Technical Service Bulletin: TSB220244

Idler Pulley Bracket Installation for Option FA1611 and FA1608

Figure 1, Existing P-clip Location.

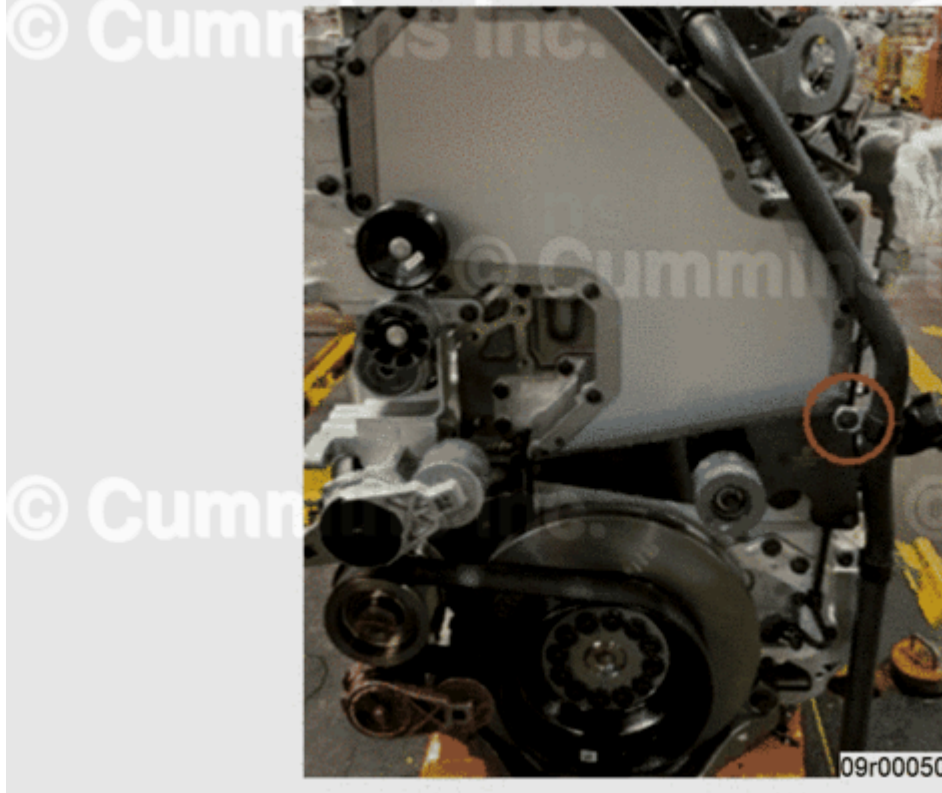
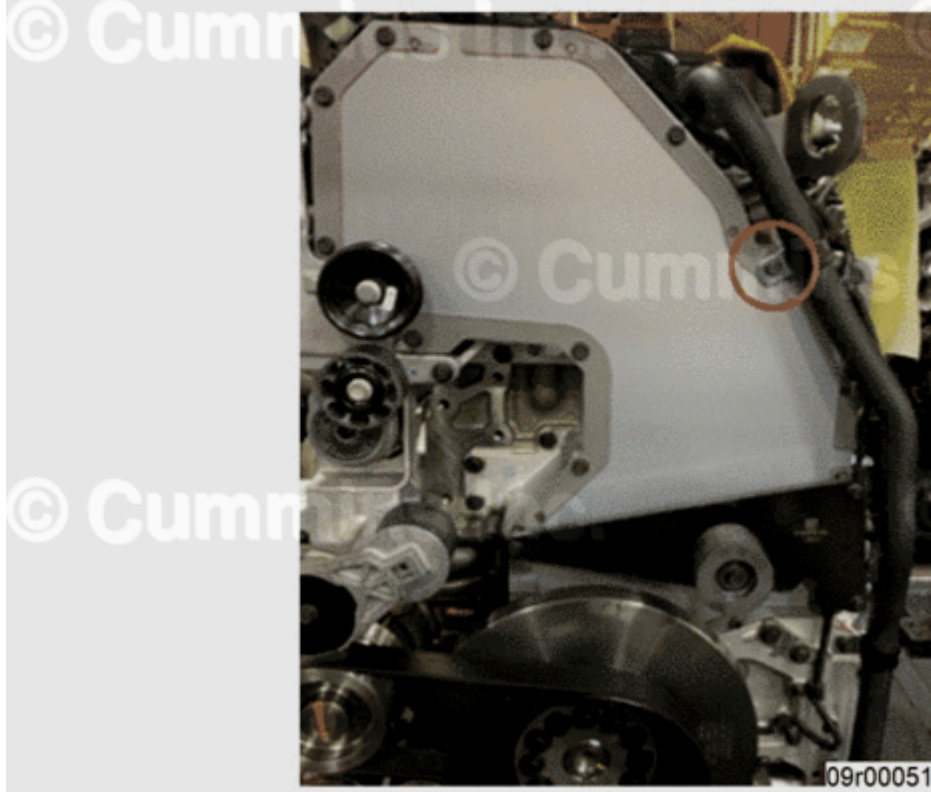
The previous idler pulley bracket, part number 3688069, load column had a soft p-clip under the capscrew and insufficient thread engagement resulting in poor bolt load retention and risk of thread strip. This change moves the p-clip to an alternative location, increases thread engagement, and increases the capscrew grade to allow an increase in installation torque.

- Remove and discard capscrews, Part Number 3901446, see Table 2.
- Relocate P-clip for breather tube options BR1774 or BR1775 from hole number 6 (seen in Figure 1) to hole number 3 (seen in Figure 2), according to the gear cover capscrew numbers displayed in Figure 3.
- Install capscrews, Part Number 3966976, see Table 2.

- Torque to 41 N•m [30 ft-lbs]
